Docket Nos. 50-269
50-270
and 50-287

These amendments provide Oconee Unit 1 control rod position and operational power imbalance limits for four-pump operation applicable to the period after 245 + 10 Effective Full Power Days of operation.

OCONEE NUCLEAR STATION, UNIT 1

AMENDMENT NO. 15 TO FACILITY LICENSE NO. DPR-38
CHANGE NO. 25 TO TECHNICAL SPECIFICATIONS;

Figure 3.5.2-1A2

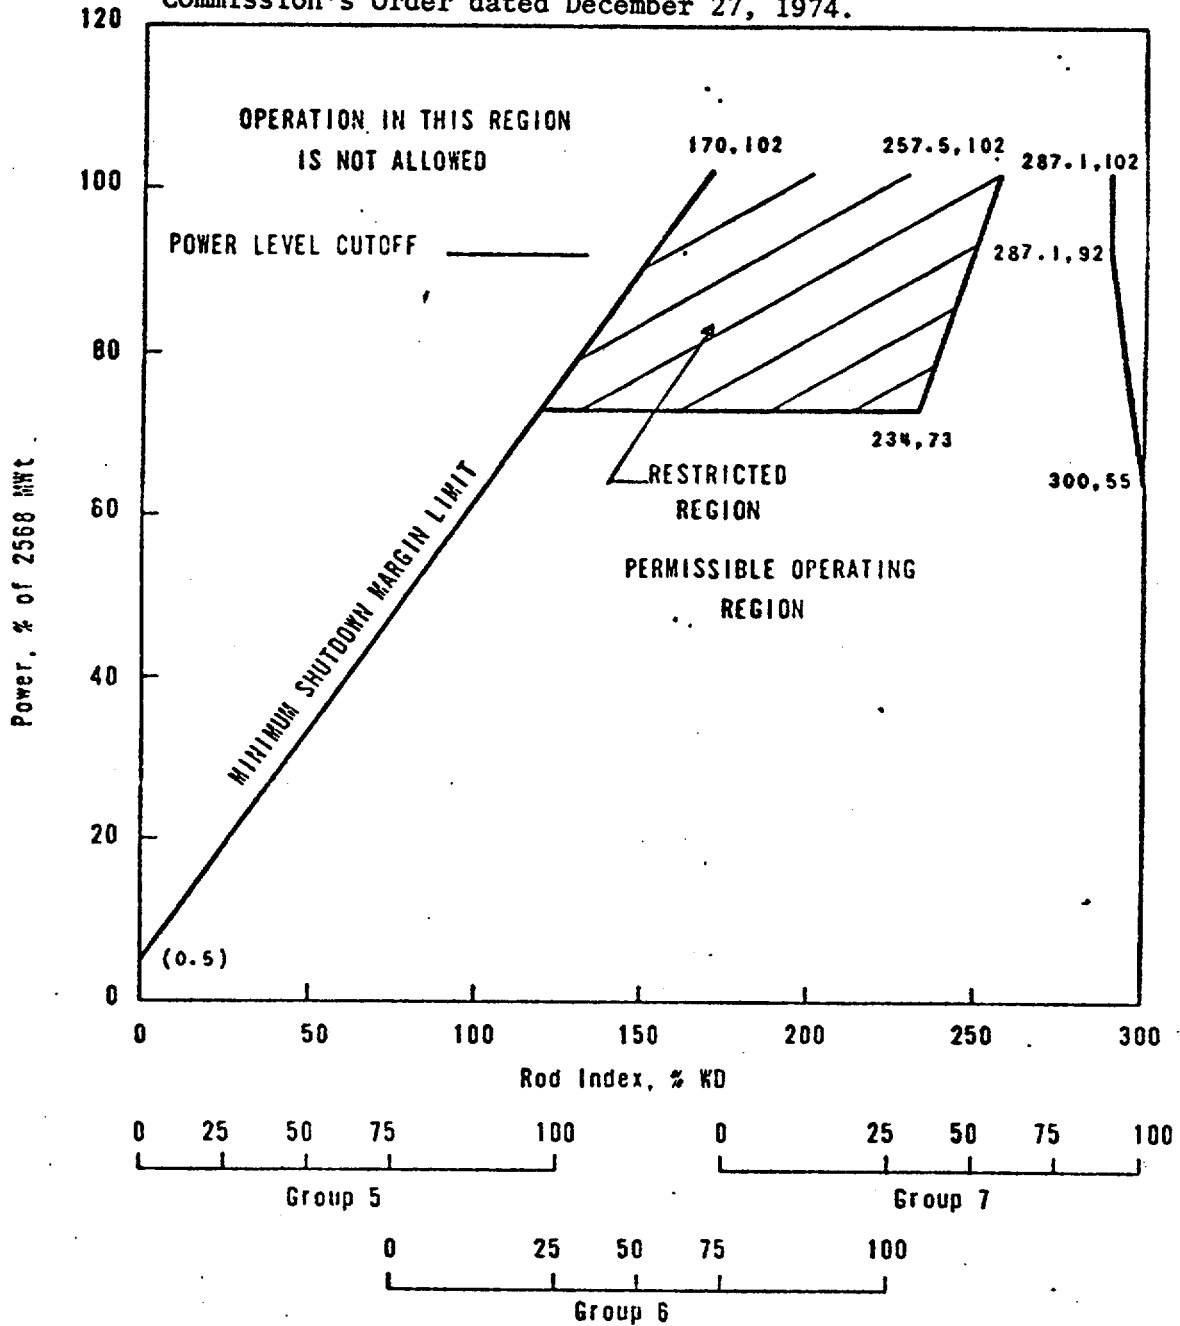
ROD POSITION LIMITS FOR 4 PUMP OPERATION APPLICABLE TO THE PERIOD AFTER 245 ± 10 EFPD, as provided for in the Commission's Order dated December 27, 1974.

Rod index is the percentage sum of the withdrawal of Groups 5, 6 and 7.

UNIT 1
ROD POSITION LIMITS FOR
4 PUMP OPERATION
OCONEE NUCLEAR STATION

The proposed rod withdrawal and axial power imbalance limits for operation beyond 245 ± 10 EFPD were calculated by the licensee using methods we have previously found acceptable and upon which we relied in establishing the necessary operating restrictions in the Order. We, therefore, conclude that operation of Unit 1 beyond 245 ± 10 EFPD with the proposed rod withdrawal and axial power imbalance limits, and with no change in the other operating restrictions in the Order, will assure that ECCS cooling performance will continue to conform to all of the criteria contained in 10 CFR §50.46(b), which govern calculated peak clad temperature, maximum cladding oxidation, maximum hydrogen generation, coolable geometry and long-term cooling.

The incorporation of these new limits in the technical specifications does not conflict with nor require revision of the Order since with respect to the rod withdrawal limits, the requirement for new limits

(for operation beyond 250 EFPD) was recognized and provided for in the Order and, with respect to the axial power imbalance limits, the new limits are more restrictive than those in the Order.

In summary, we have concluded that the proposed rod withdrawal and power imbalance limits for Oconee Unit 1 meet the requirements of the Order of December 27, 1974, and provide reasonable assurance that the public health and safety would not be endangered. We, therefore, find the proposed amendment to be acceptable.

Figure 3.5.2-3A

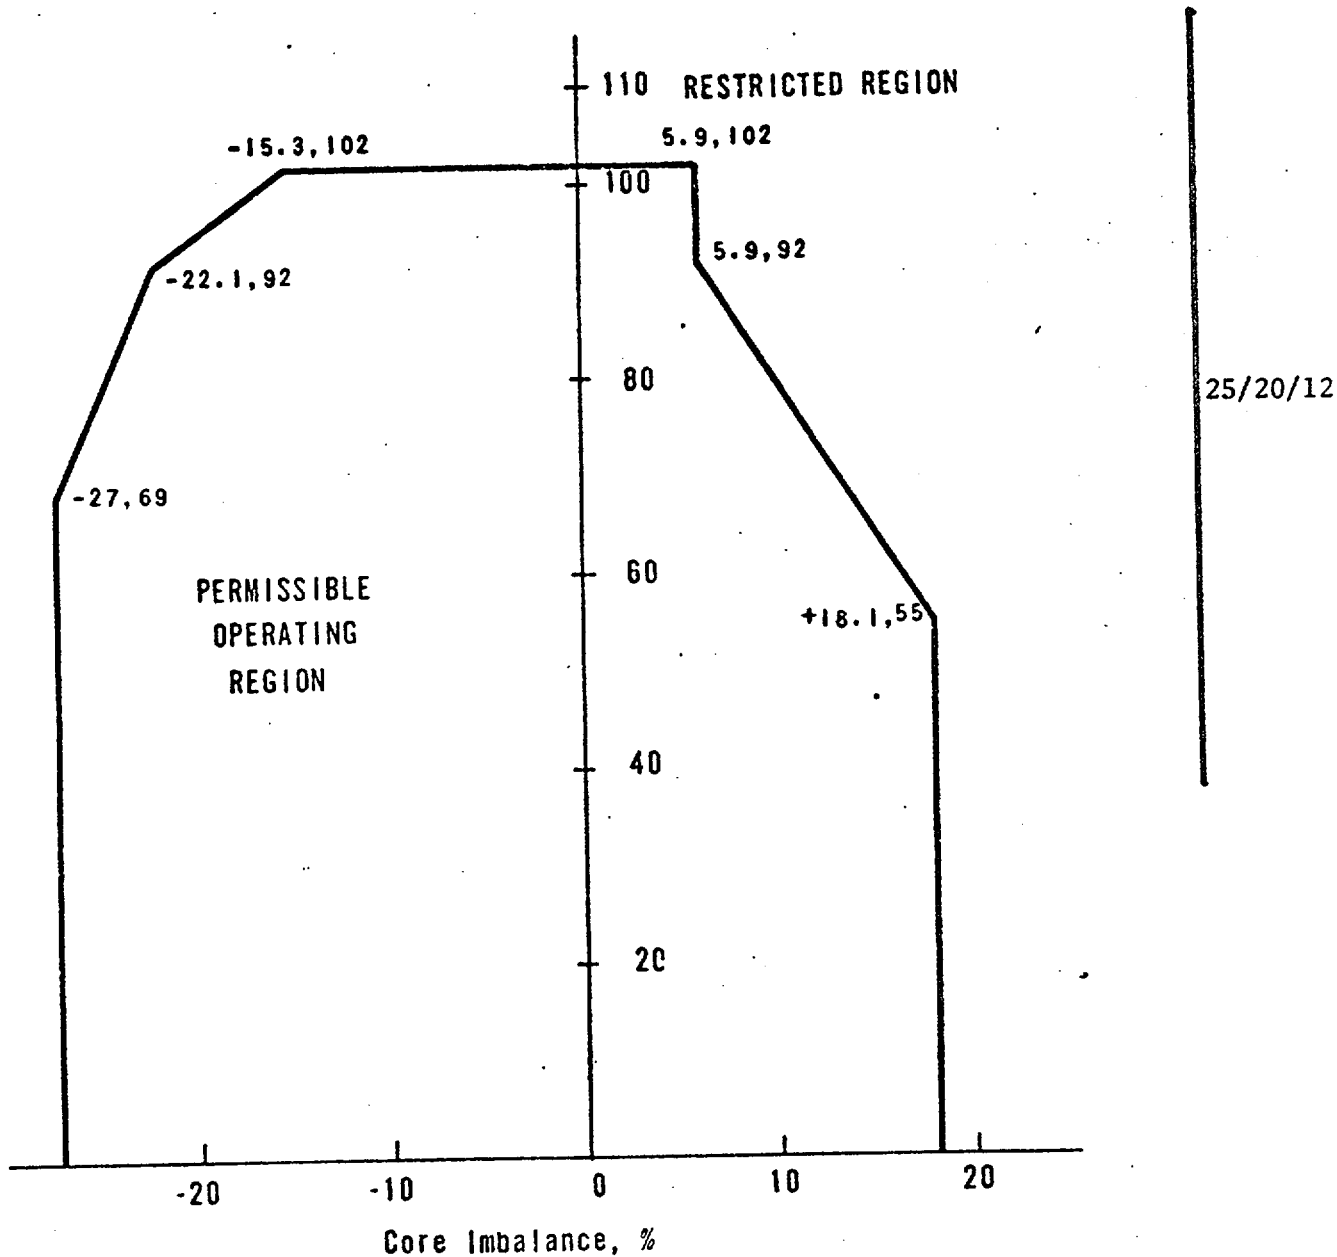
UNIT 1
OPERATIONAL POWER IMBALANCE ENVELOPE
